**City of Portsmouth, NH**  
**Bid #29-13 Mechanic Street Seawall at Pickering**

**ADDENDUM No. 1**

**Issued February 25, 2013**

SHEET NO. 5 OF 9

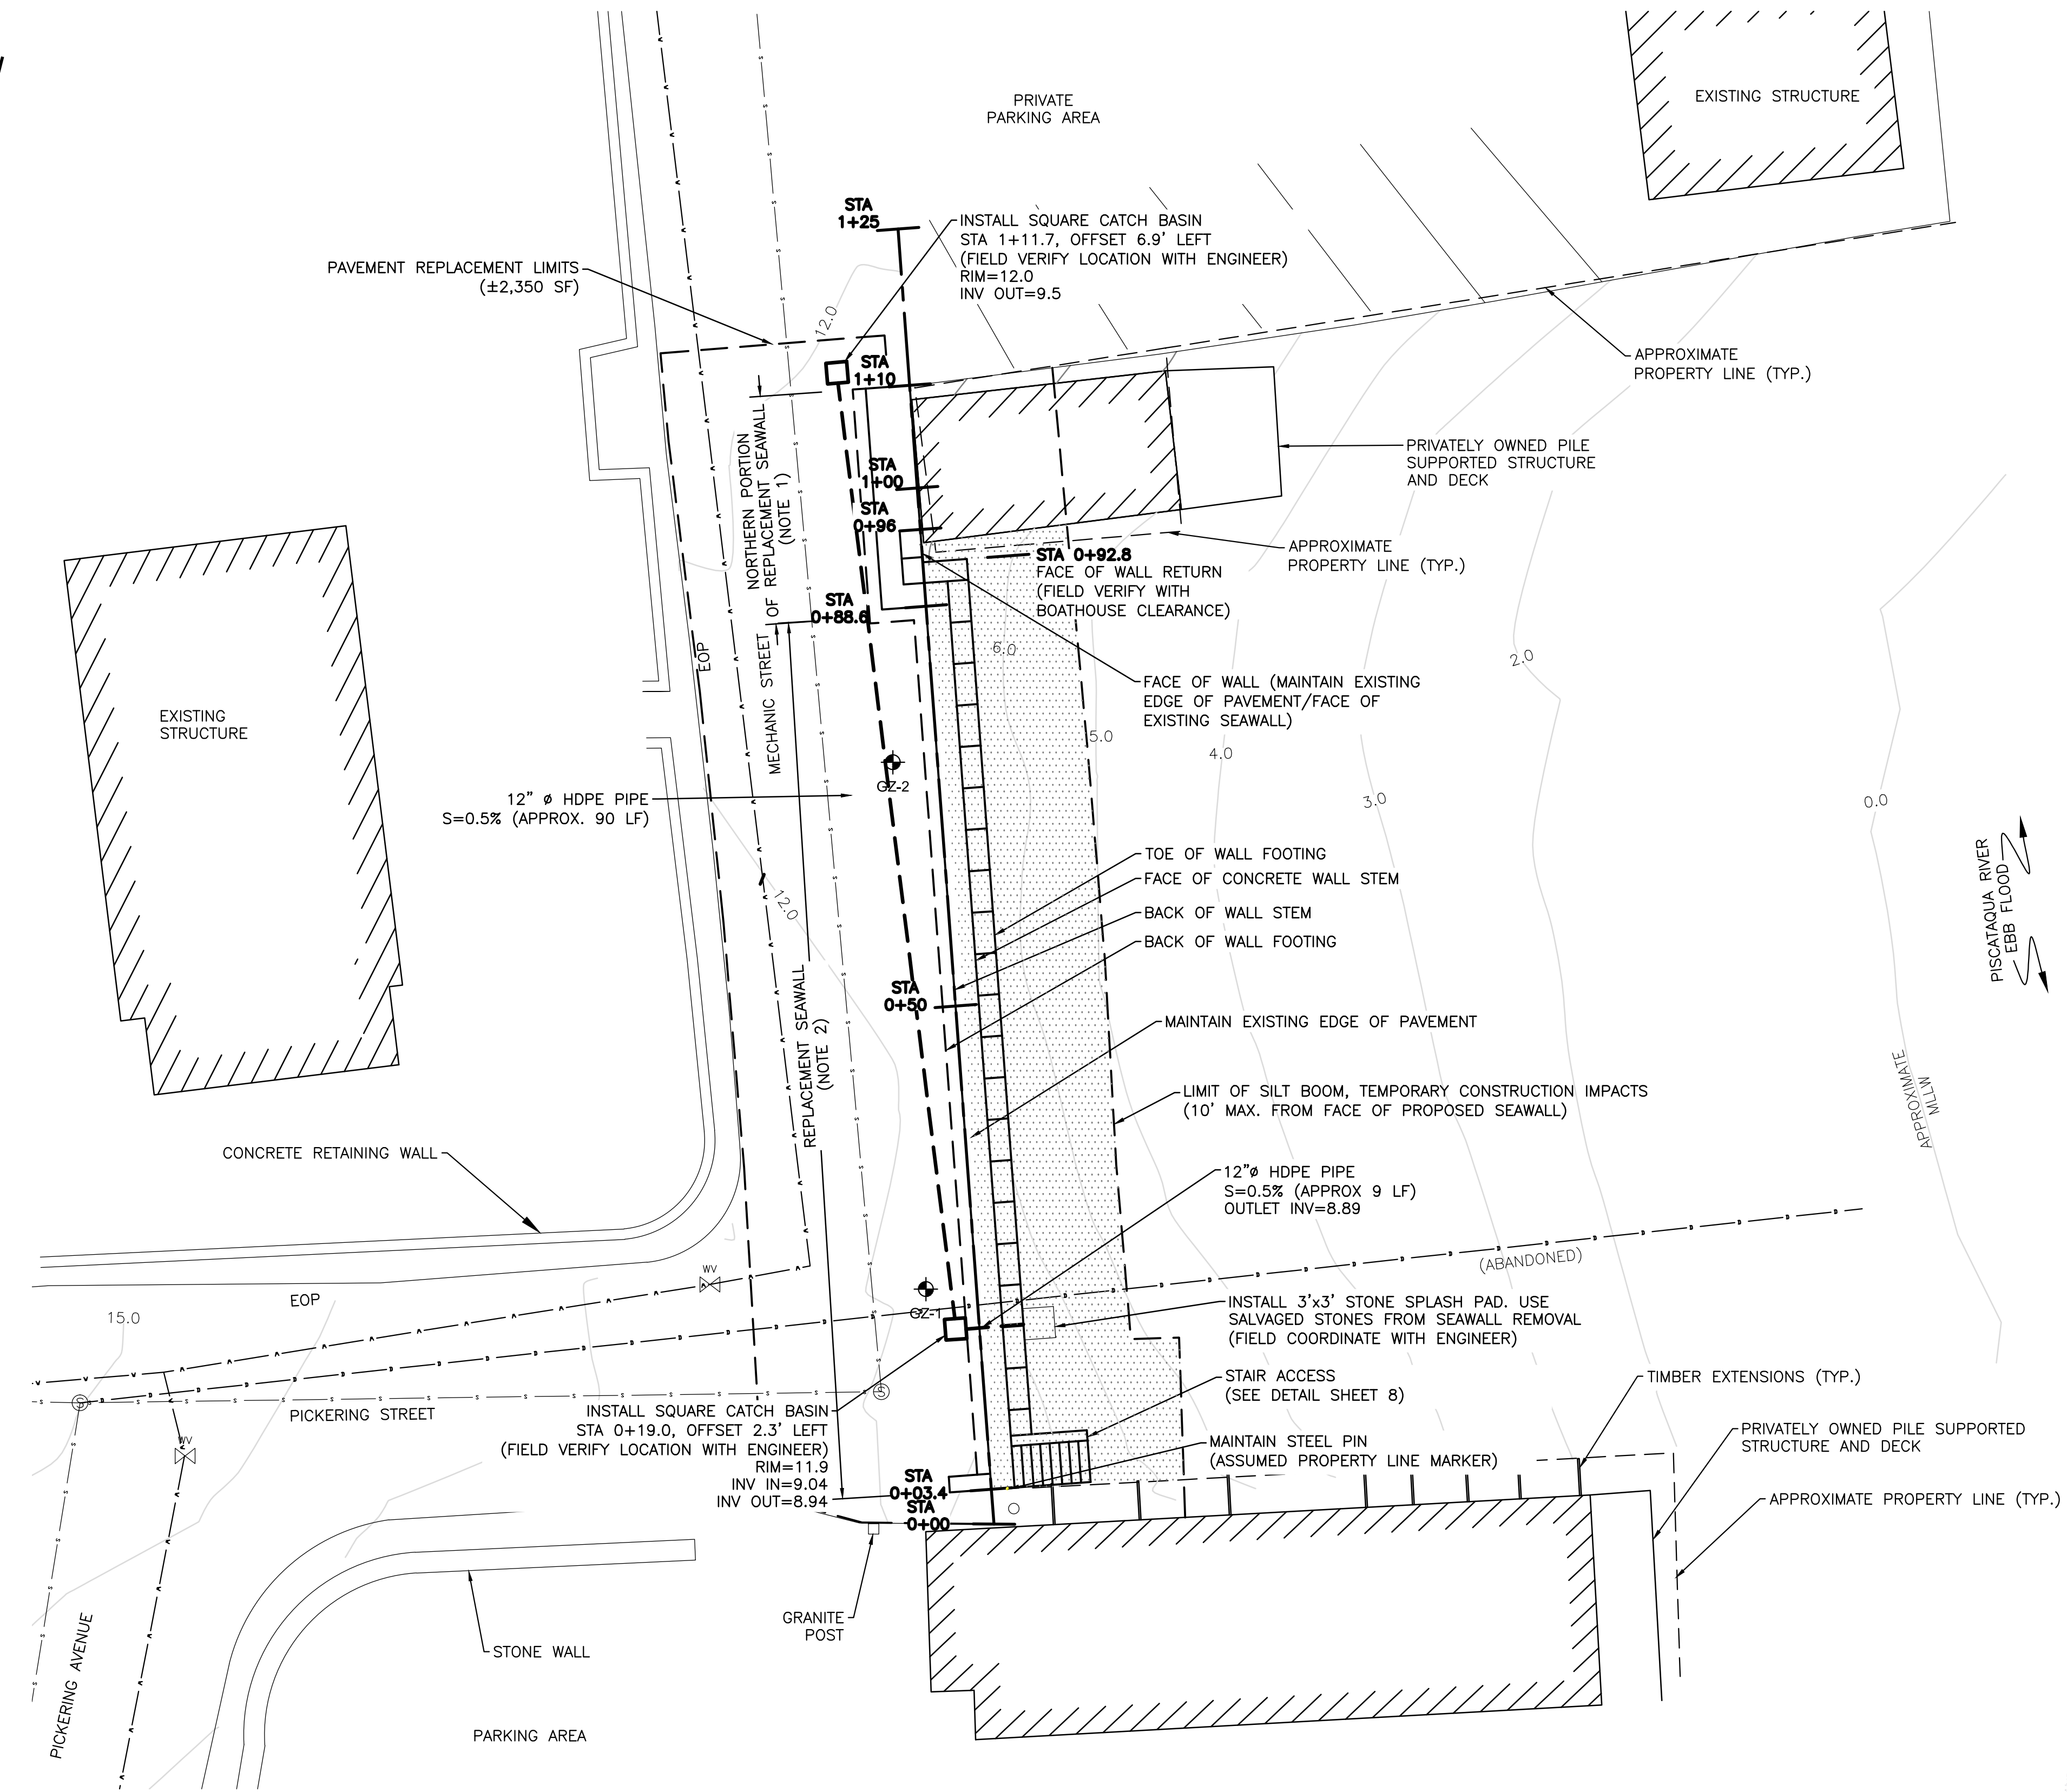
3. What is the stationing at the jog in the wall?

15. Is a spud barge ok within the cofferdam?

Response: Drawing 5, Mechanic Street Seawall Replacement Plan, shows face of the granite stone at the return wall at STA 0+92.8. However, this requires field verification to provide adequate clearance for construction methods/excavation for the seawall footing and the boathouse and its piles.

Response: The NHDES permit does not include conditions specific to barge usage. Use of a barge should be included in the Contractor's erosion control/water quality protection plan submittal to NHDES. However, it may not be possible to place a barge in the cofferdam system as the permit limits the waterside location of the cofferdam to 10 feet from the face of the wall (see Drawing 5 of the contract documents).

PROJ MGR: CWC	REVIEWED BY: RJM	CHECKED BY: JJZ	DRAWING <b>6</b> SHEET NO. 6 OF 9
DESIGNED BY: CWC	DRAWN BY: JJZ	SCALE: AS SHOWN	
DATE: JULY 2012	PROJECT NO. 18.0170970.00	REVISION NO. 1

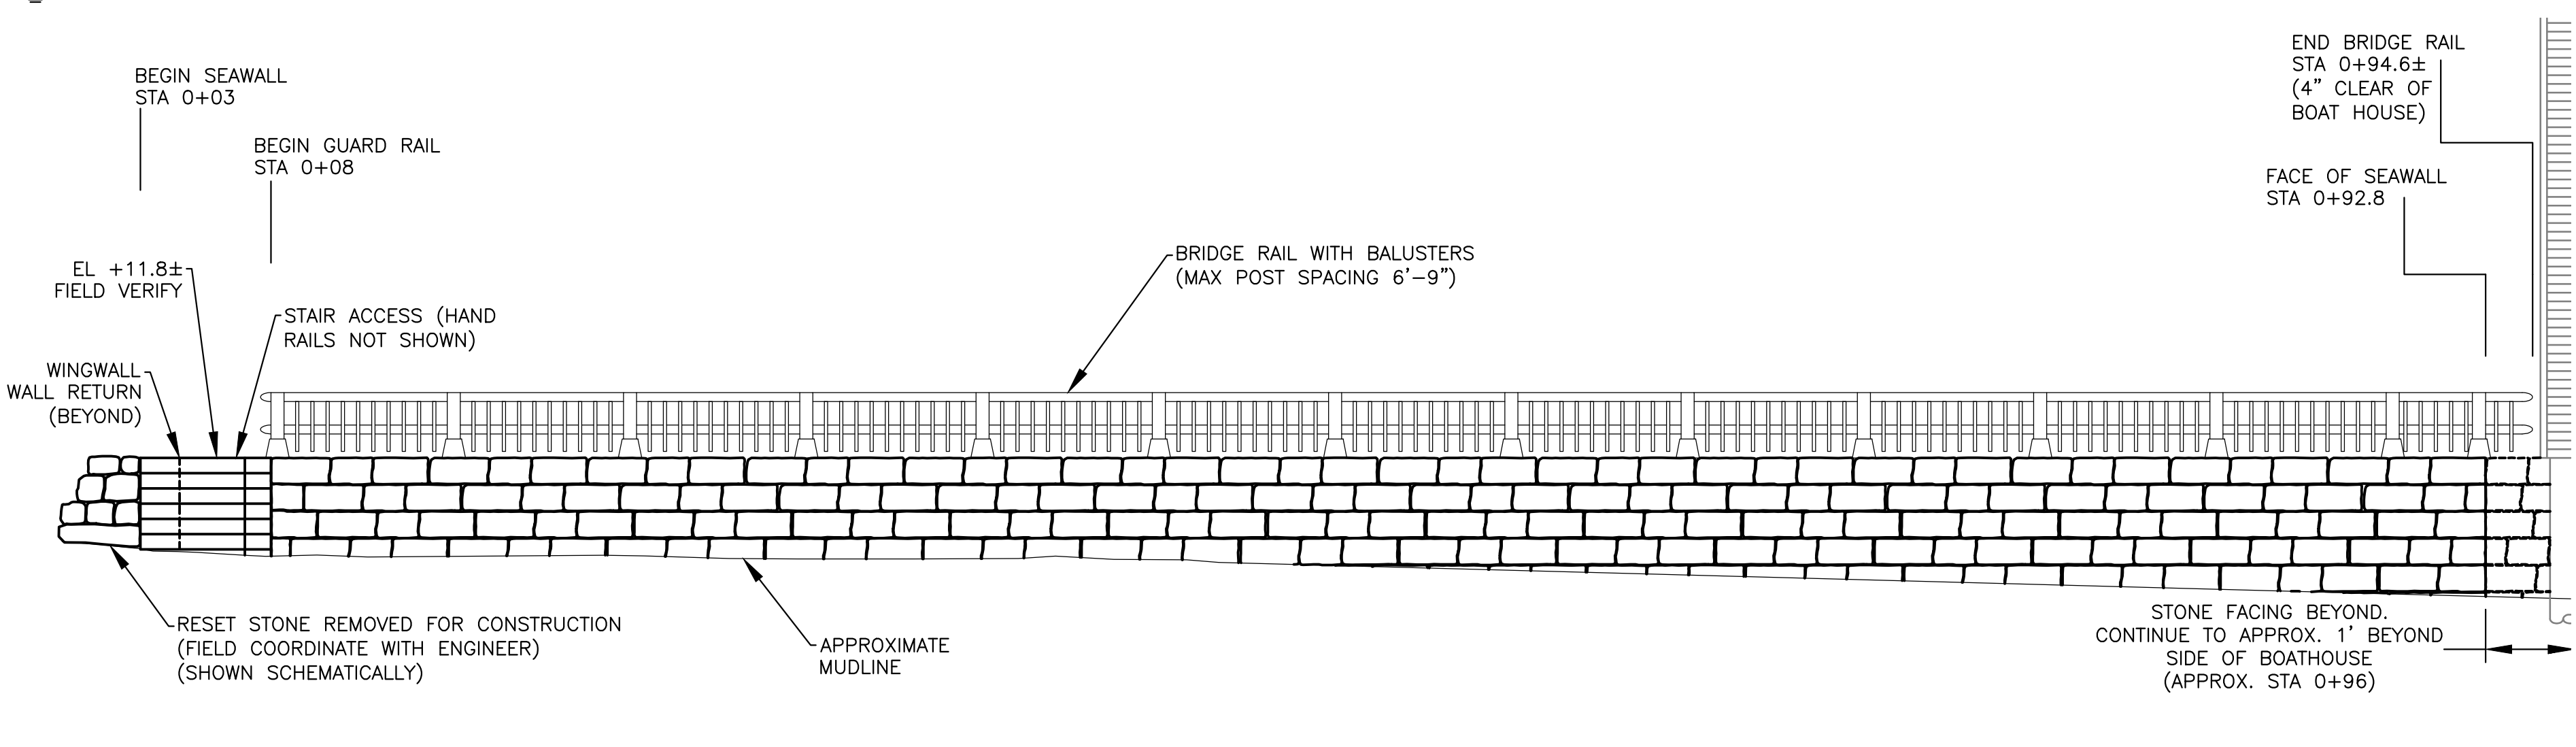
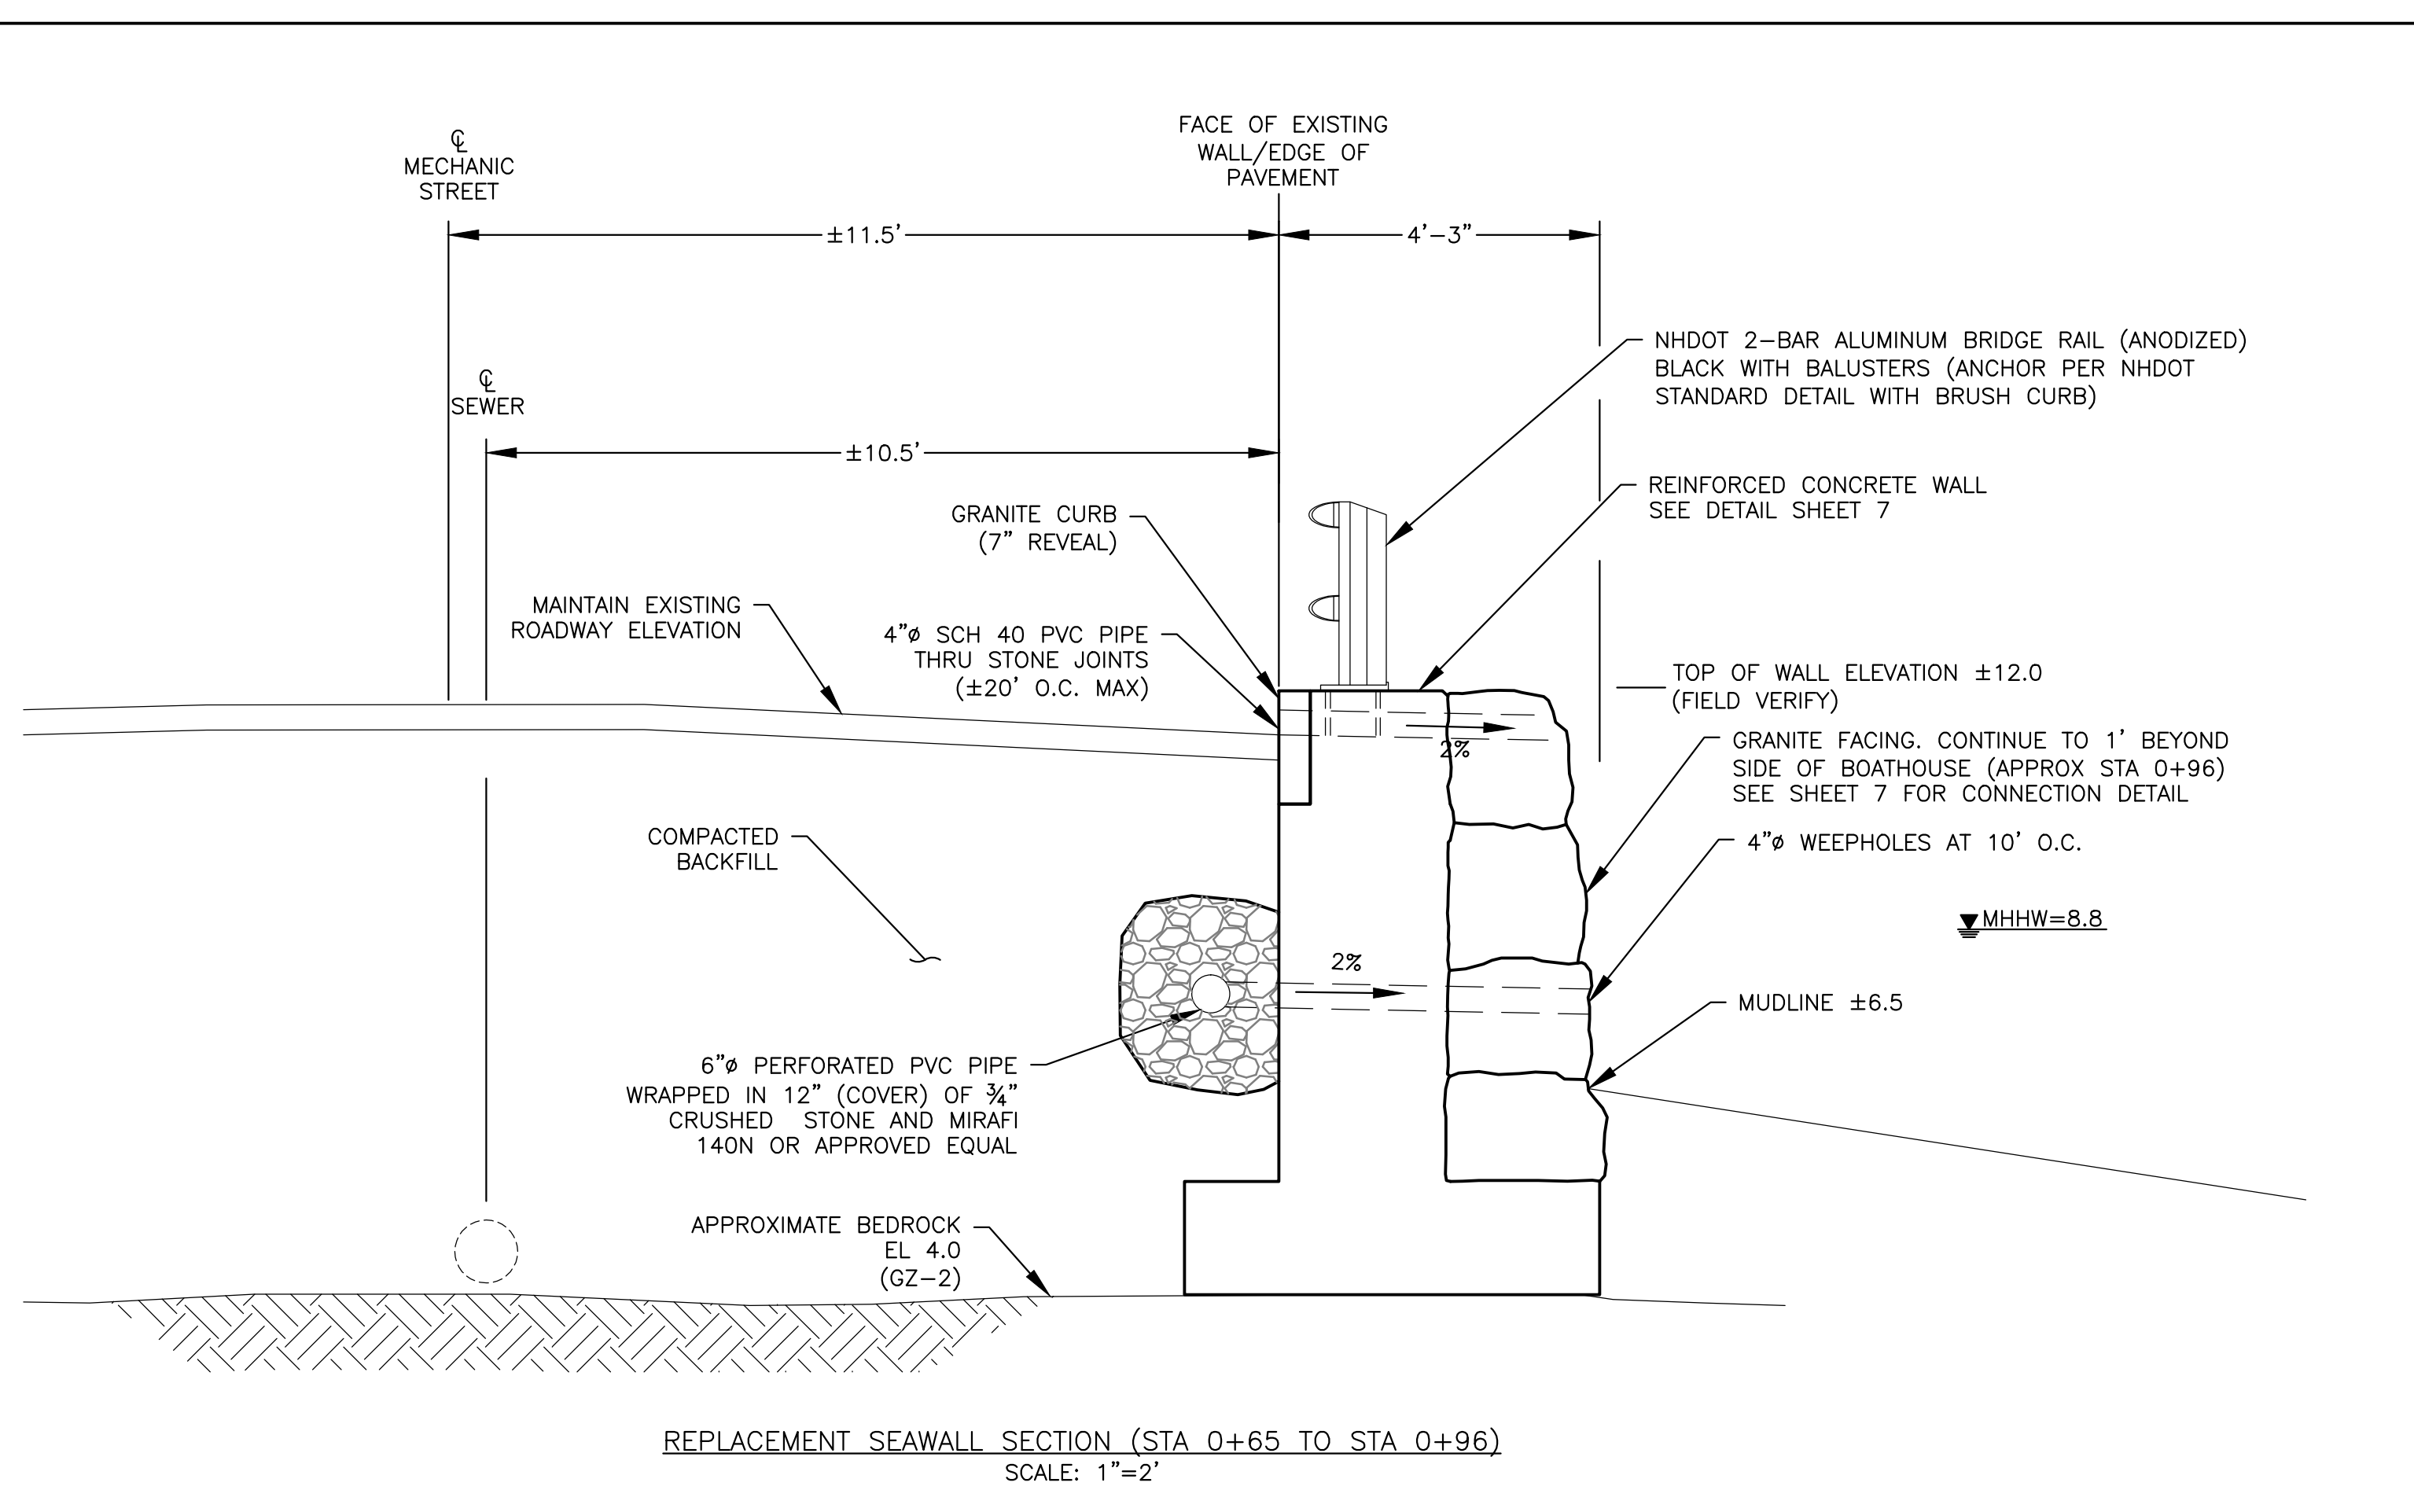
2. Drawing 6 shows a detail "Replacement Seawall Reinforcing – 0+65 to 0+88." Should that be 0+88 to 1+10?

Response: Drawing 6 has been revised to reflect corrected stationing. The section referenced in the bidder question is from STA 0+65 to STA 0+96, which is approximately 1 foot beyond the side of the boathouse.
